BRANZ REPORT

FD1882/CF02/1

REPORT ON COMPLIANCE OF A FACADE SYSTEM AT 12 SELWYN ROAD,
COCKLE BAY, AUCKLAND WITH NZBC FIRE SAFETY CLAUSES

CLIENT
Ministry of Business Innovation and Employment
15 Stout Street
Wellington
New Zealand

Figure 2 TS110 exposed fastener system

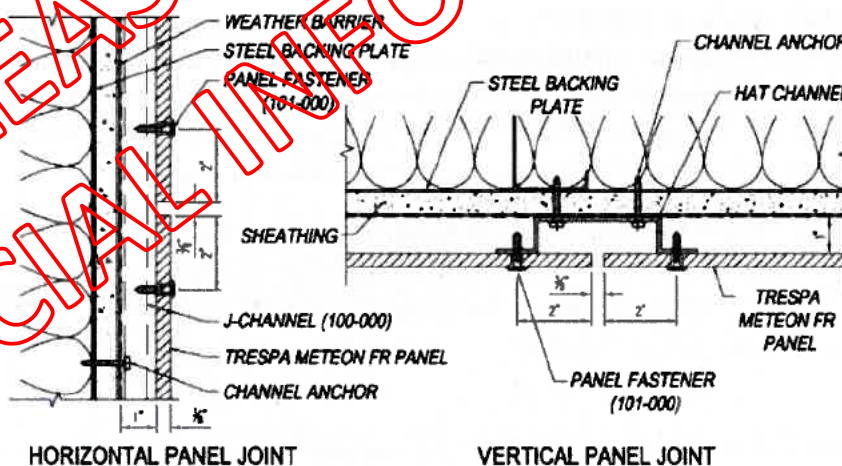
Fixing Trespa Meteon FR wall panels to the substructure with aluminium rivets rather than steel screws would most probably cause more panels to fall, or panels to fall sooner than for the case where steel screws have been used. This change does not improve or maintain the performance of the system compared to that in the fire test. While it might not result in increased flaming above the windows opening, it is

generally undesirable behaviour increasing the hazard of falling materials onto fire fighters or others located below. Depending on the combustibility of the panels, there is also the possibility of fire spread if the panels are flaming when they fall. It is however noted that the NZBC does not specifically address this type of failure mode of non-structural panels.

I note that increasing the spacing of the fixings is not likely to improve the performance of the system compared to that in the fire test. It is not really known if the performance would be maintained or not.
